**Subject:** Operator's Response to Adequacy Review, Morton Lakes (M-2008-082), concerning slurry wall installation

RE: Permit M2008-082; Morton Lakes; Technical Revision 8 (TR8) – Revisions to Mining Plan for Installation of Slurry Walls 7A and 7B with Ground Water Impact Modeling Report and Surety Increase Request - Response

To: Joe Lamanna  
From: Timothy A. Crawford  
Subject: Brannan Sand and Gravel Company LLC – Hydrogeologic Investigation of the Morton Lakes Site Stage 7A and 7B Gravel Pit Lining  
Job: 0430.08  
Date: December 21, 2022

**Figure 1**  
**Brannan Sand and Gravel Company LLC**  
**Morton Lakes General Location Map**

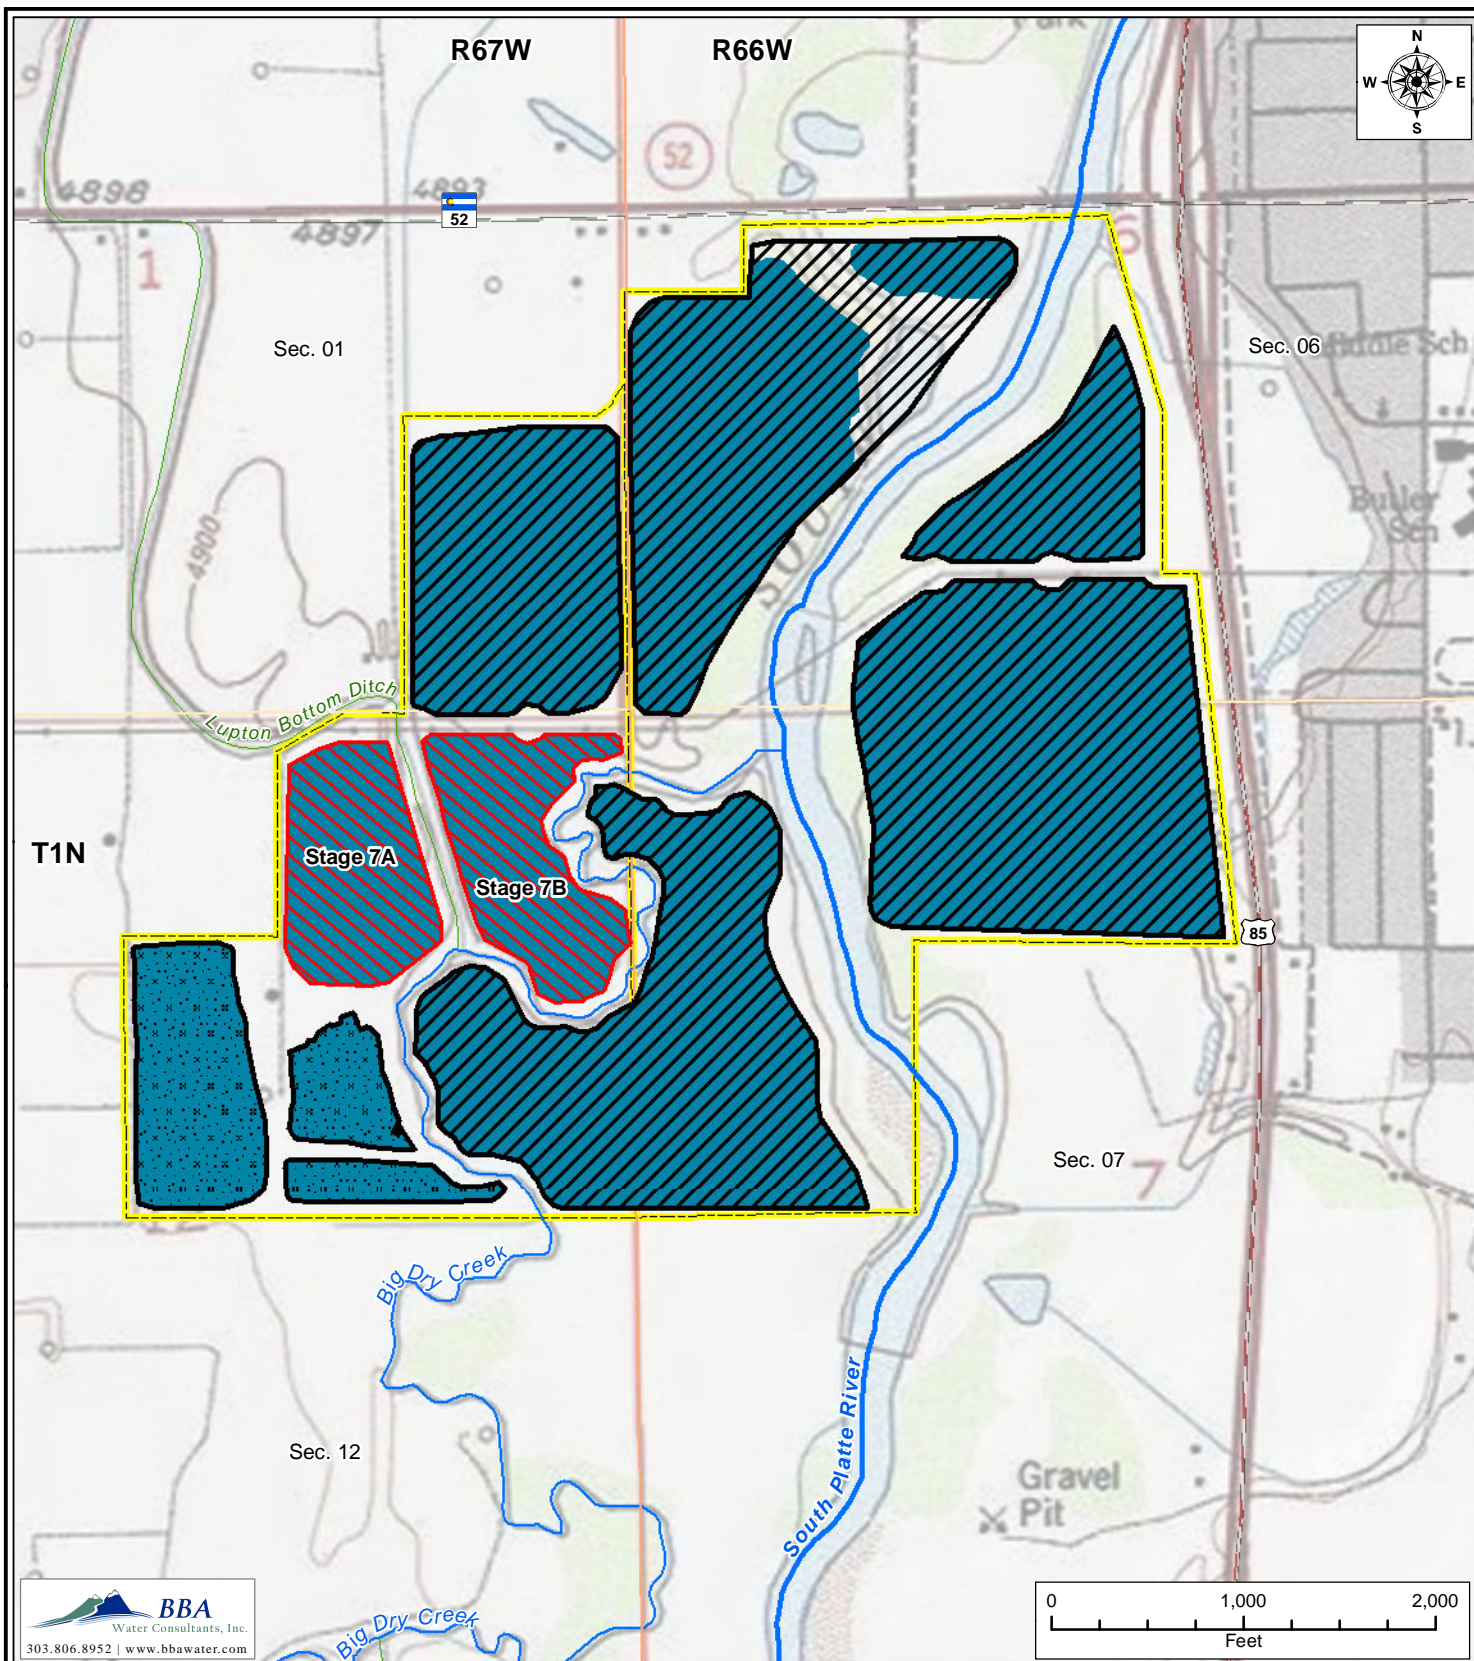
1. The DRMS requested clarification regarding whether the modelling considered only the Stage 7A and 7B gravel pit slurry walls or considered all of the Morton Lakes mine site slurry wall lined gravel pits and existing unlined ponds.

- a. The MODFLOW model prepared to investigate the impacts of the Stage 7A and 7B gravel pit liners includes features to model all of the Morton Lakes mine site slurry wall lined gravel pits and existing unlined ponds. The attached Figure 1 presents the general locations of these areas. The model was, however, prepared to investigate the potential impact of the addition of the Stage 7A and 7B gravel pit slurry walls. Accordingly, the pre-lining condition model run was performed with all of the existing slurry walls and ponds except for the Stage 7A and 7B liners. The Stage 7A and 7B liners were added to subsequent model runs to investigate the impact of the addition of the proposed liners to the existing system.

**Figure 2**  
**Brannan Sand and**  
**Gravel Company LLC**  
**Morton Lakes Surface**  
**Elevation Map**

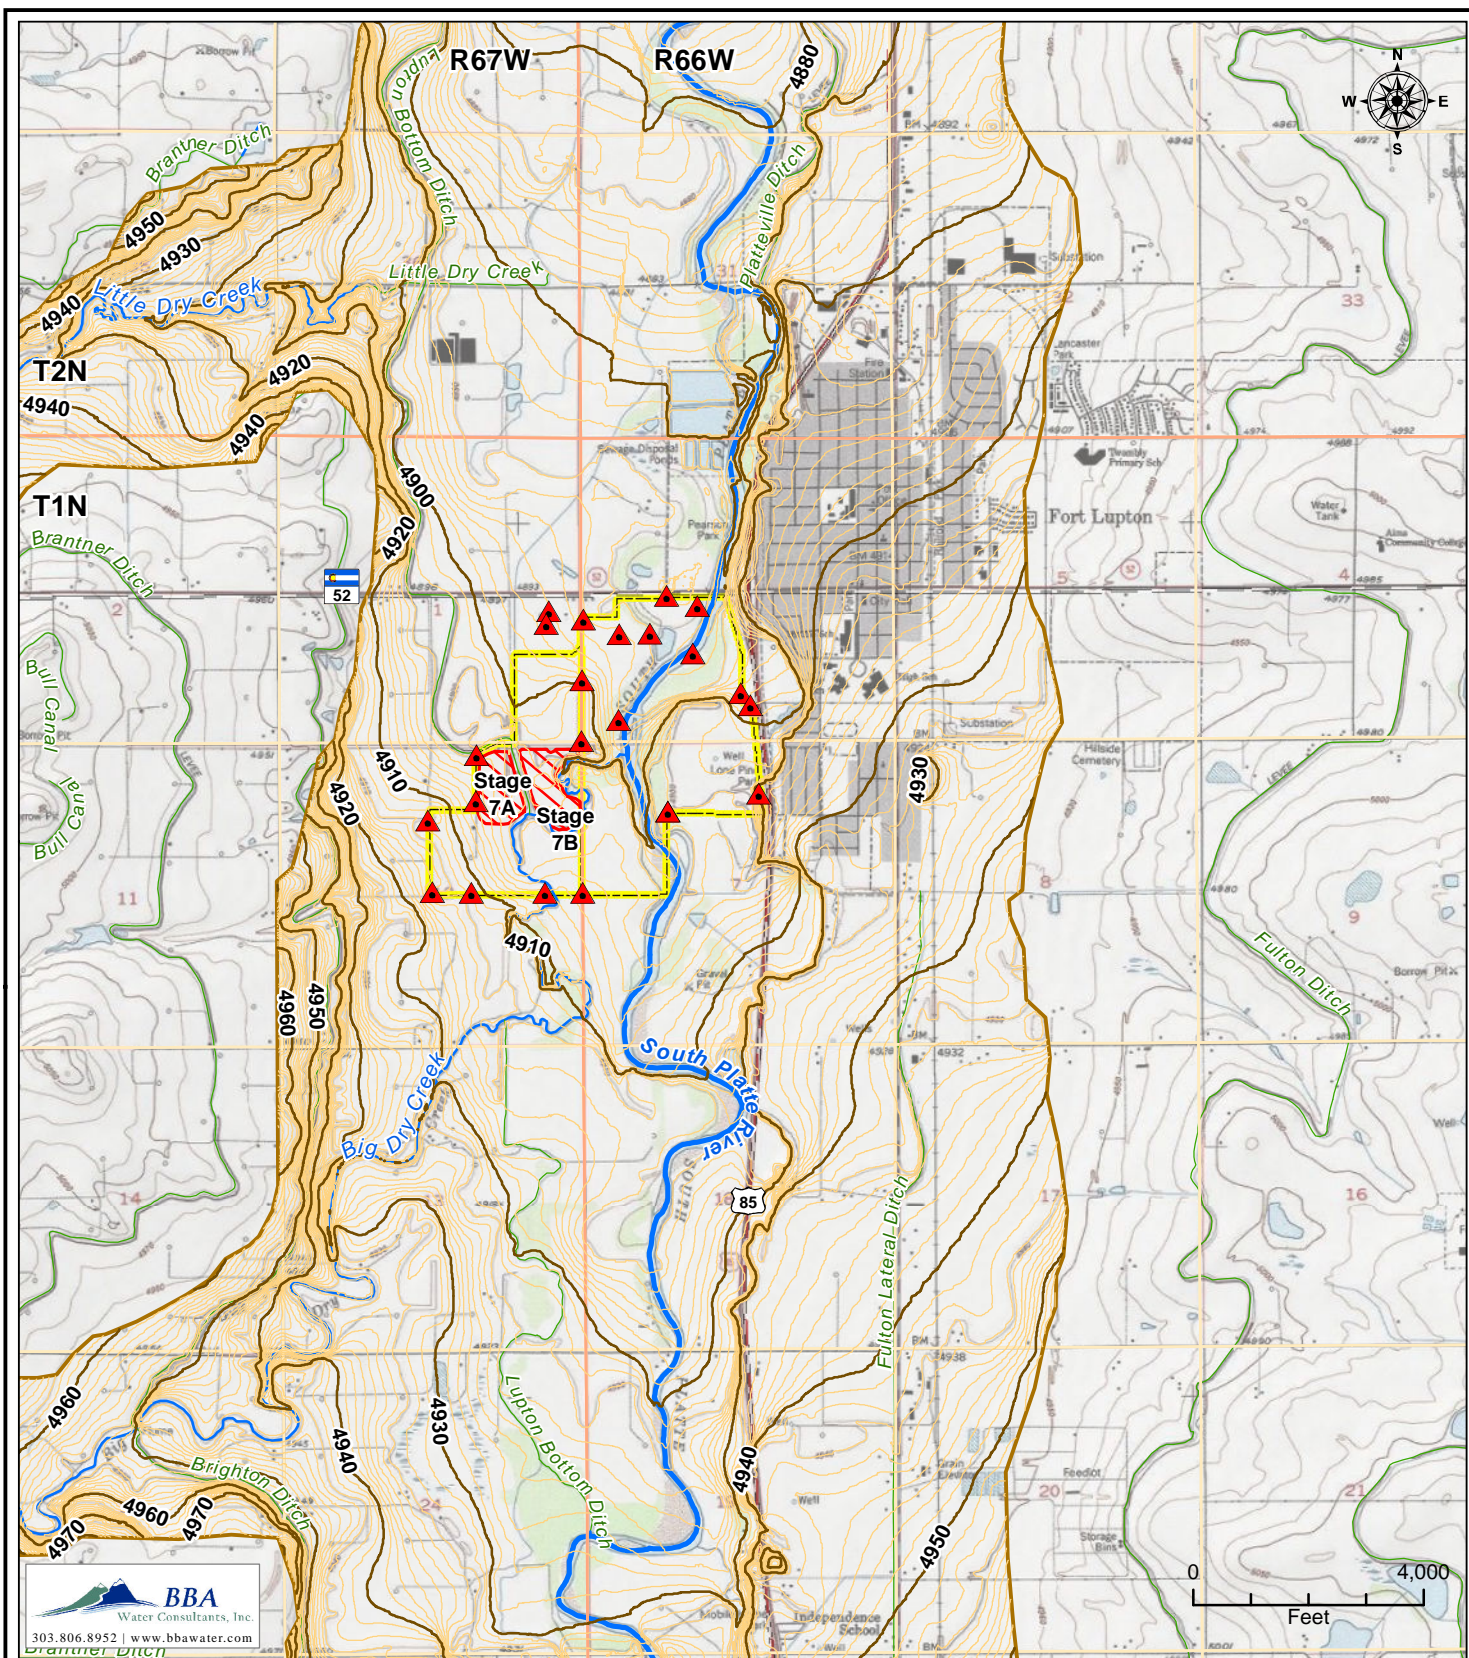
7. The DRMS has requested figures that present the following:
- a. Well locations and surface elevations / contours used to develop the model. This figure has been provided as Figure 2.
  - b. The model grid utilized for the model domain. This figure has been provided as Figure 3.
  - c. Pre- and post-slurry wall lining ground water elevation maps. These figures have been provided as Figure 4 and 5.

**Figure 3**  
**Brannan Sand and**  
**Gravel Company LLC**  
**Morton Lakes Stage 7A and**  
**7B Gravel Pits**  
**Pre-lining Water Level Elevation**

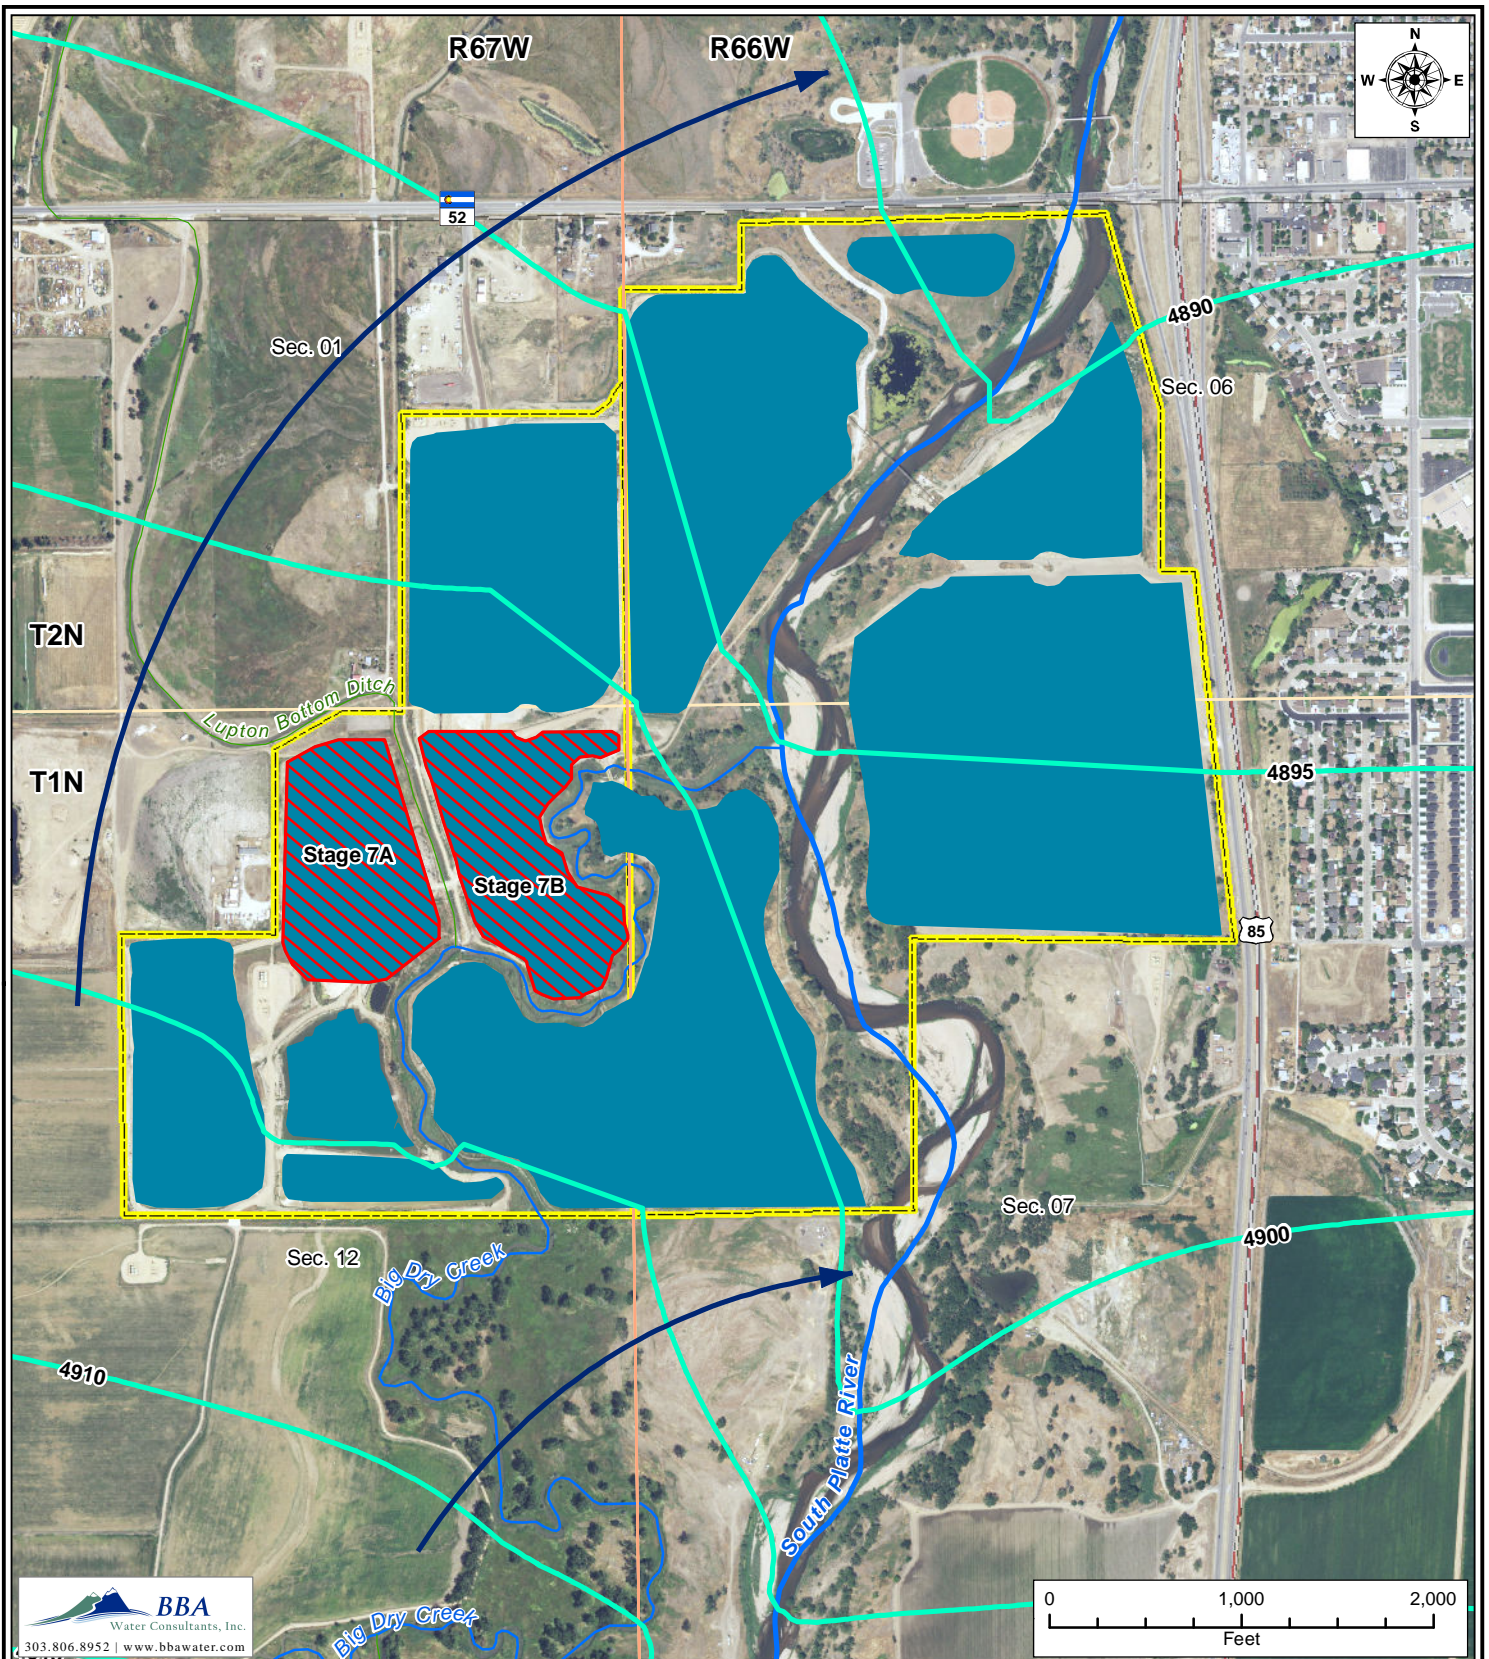
4. The DRMS has requested additional detail regarding how the model addresses the SEO's previous concerns regarding the impact of the slurry walls on return flows from regional recharge projects communicating with the South Platte River.

- g. Figure 4 from our original summary may have inadvertently been excluded from our original submittal. We have reattached our technical summary with Figure 4 attached for clarity. The comparison of Figure 3 and Figure 4 from that summary provides the comparison of the pre- and post-lining water level conditions.

- Figures 2 presents the modeled changes in water level elevation associated with the gravel pit lining.
- Figure 3 presents the pre-lining ground water elevations and flow paths and Figure 4 presents the post lining ground water elevations and flow paths.
